APPLICATION FOR ZONING CHANGE

Date 2-25-91NAME OF PROPOSED DEVELOPMENT Steger Retail AdditionLOCATION OF PROPOSED DEVELOPMENT N.E. corner of FM 740 and
FM 3097NAME OF PROPERTY OWNER/DEVELOPER Estate of O.L. Steger, Jr. and Emily Sue
Whitehead
c/o Lakeside National BankADDRESS P.O. Box 9PHONE (214) 771-8311Rockwall, Texas 75087NAME OF LAND PLANNER/ENGINEER Winkelmann & Associates, Inc.ADDRESS 12800 Hillcrest Road, Suite 200PHONE (214) 490-7090Dallas, Texas 75230TOTAL ACREAGE 4±CURRENT ZONING ANUMBER OF LOTS/UNITS 1PROPOSED USE FOR DEVELOPMENT Grocery Store

FOOD LION, INC. SITE #50a
F.M. 740 @ F.M. 3097
Rockwall County
Rockwall, Texas

I have reviewed the preliminary information that has been submitted in conjunction with this request. Additionally, the Planning and Zoning Commission reviewed the plans in their last worksession and our comments regarding the proposed development are as follows:

JOB NO.	91-06
DATE	3-19-91
DRAWN	M.T.B.
CHK	J.D.H.
SHEET	A-3
OF 19	
EXTERIOR ELEVATIONS	
3390-DB 1Z

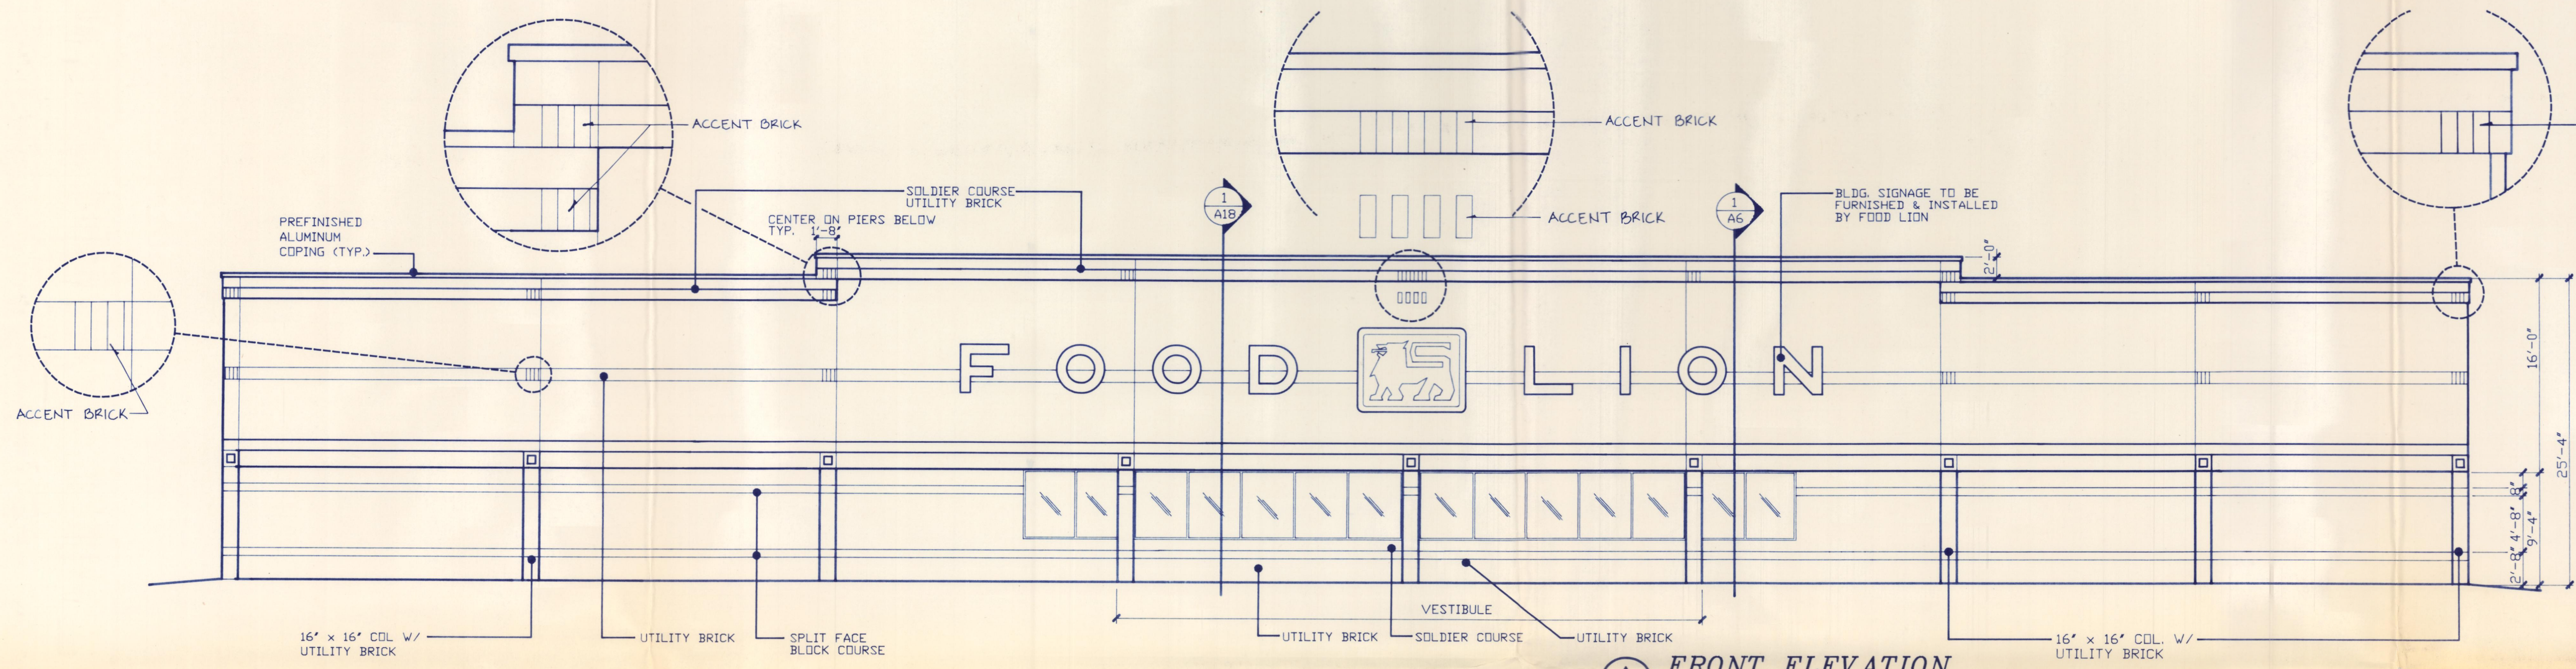
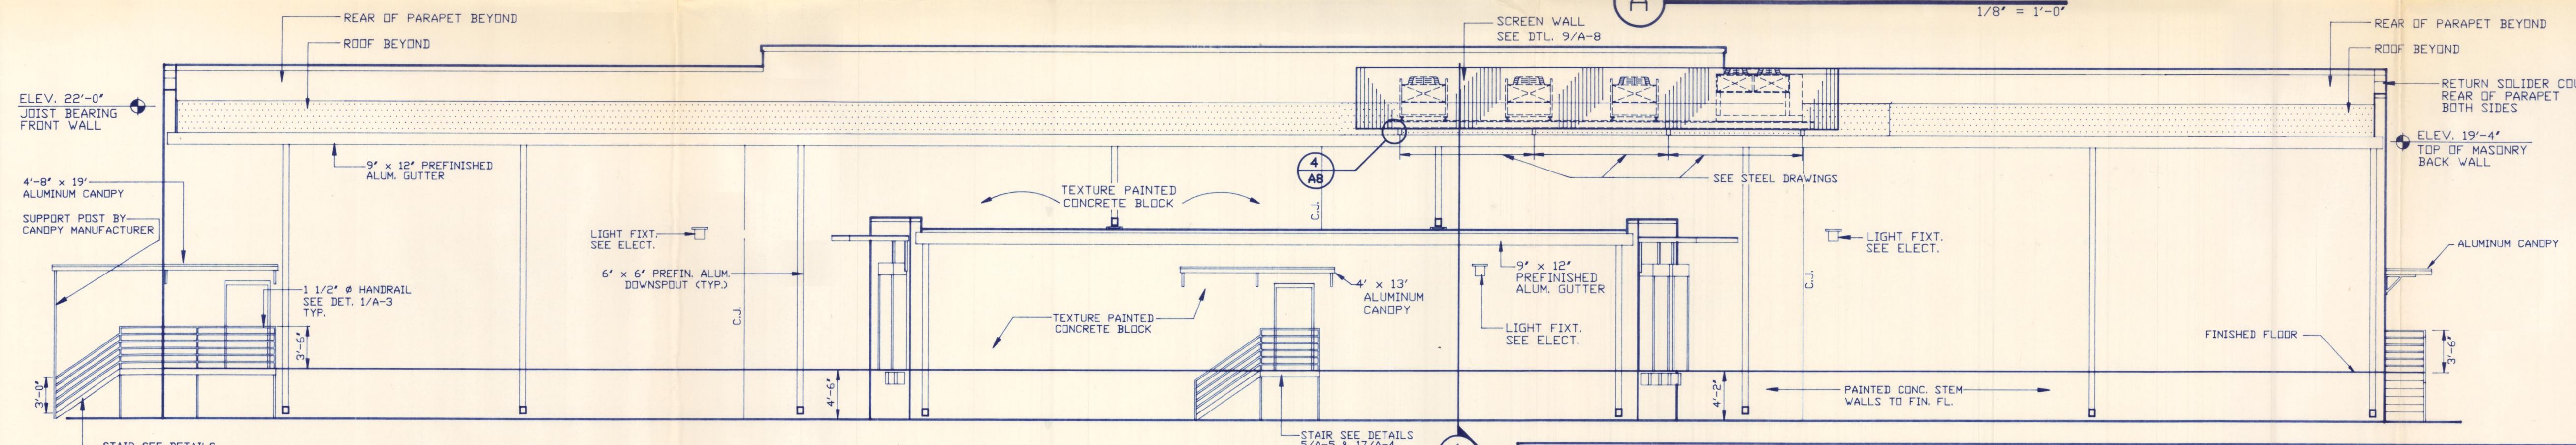
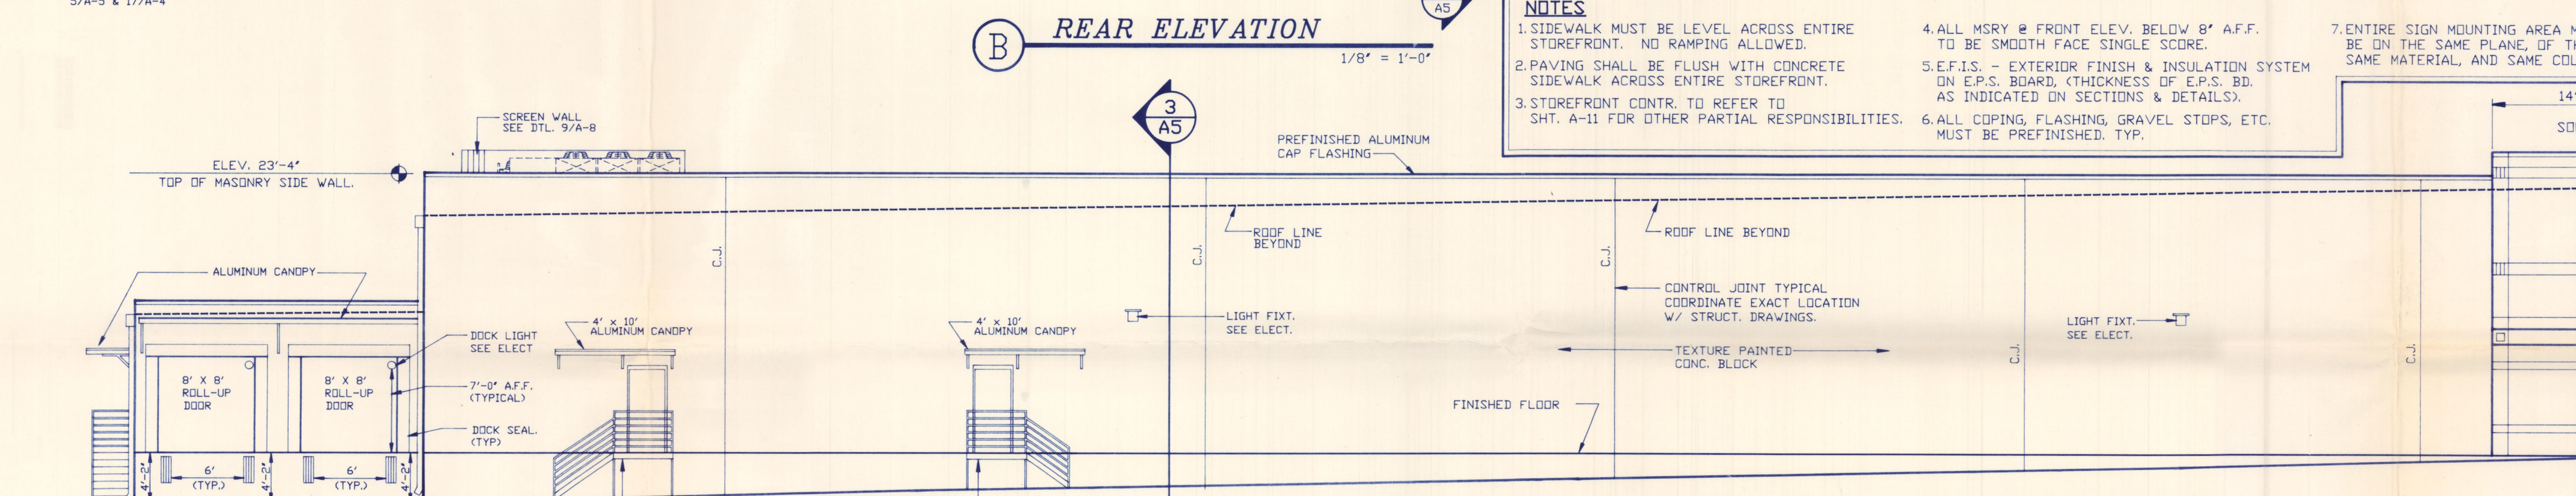
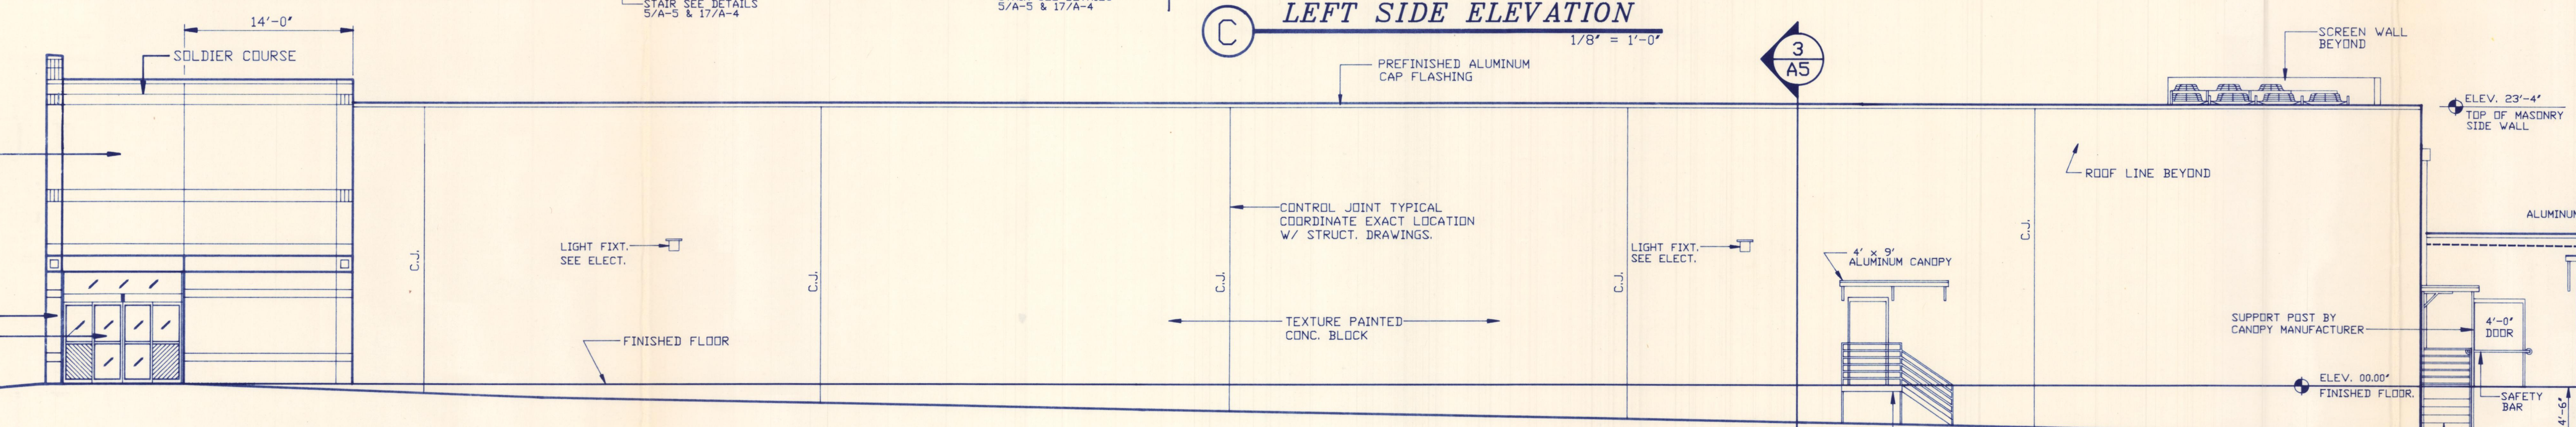
add windows & color to top &
Bottom on front elevations

add Brick to 8+18 on both sides

1. The building facade in front is not like the facade approved at the other location. The previous location included a taller front parapet with wrap around brick to give the facade more substance. The Commission will want to know why this change was made. One of the purposes of the wrap around on the sides was to help screen the roof mounted deli utility equipment. Will this equipment be used in this building?

2. What type of roof mount screen will be used around the utility equipment to the rear and will that screen be used on three sides?
3. The previous plan included brick around all four sides of the building. This location will not have the visibility of the previous location but the sides will be totally visible until there is additional development. Even when additional development occurs some of the sides will continue to be visible. The Commission expressed some concern about this issue. There is additionally no guarantee that future buildings will be located adjacent to this building. The Commission also expressed concern about the use of concrete block. There was some discussion about a stucco type paint material that might be used to surface the block. You need to be prepared to discuss this issue at the Architectural Review meeting as I am sure that it will be raised.

4. Please identify the material for the screens around the dumpster locations. It generally should match the material on the main structure.
5. Will the stairs in the rear be of the same bronze color as the coping along the top of the building? They were planned to match under the previous plan.
